SCHEMATIC

7749-E-30-4-89

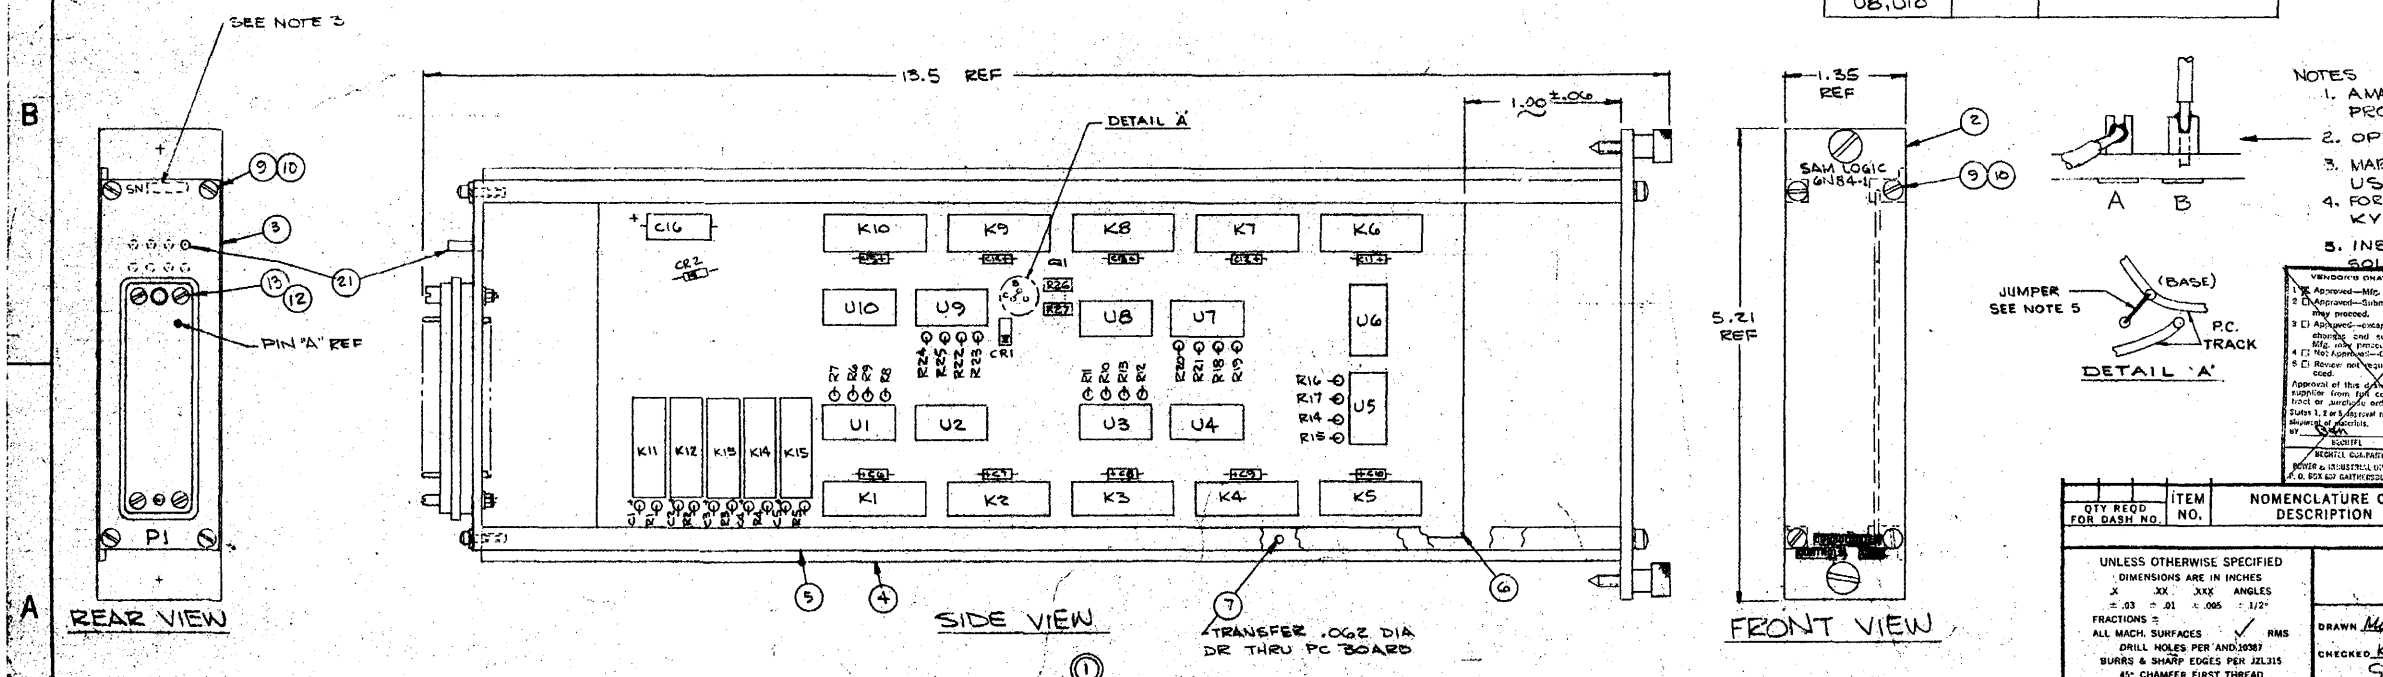
C	C/N 4829	REVISOR SCH 1 WIRE LIST FOR WIRE 26, 27, 29, 30, WAS HISTORY 26	7/20/72	
D	C/N 4825	REVISOR TO ORIGINAL CONN. (REV. C INVALIDATED)	8/1/73	
E	C/N 4831	ADDED CR-2	4/16/74	
F	C/N 5102	DEL'D Q1 FROM ZONE BC; ADDED JUMPER FROM R26 TO R27, ZONE AA, DEL'D Q1 FROM PICTORIAL ZONE 7C, ZONE HH; ZONE CC, U WAS FF, ZONE 4C, FF WAS W; ZONE 3C, HH WAS Z; WIRE LIST CORRECTED	8/1/77

THE ATI SIGNAL HAS BEEN DISABLED AND IS NOT FUNCTIONAL (P.C. FIDCR 91-0100).
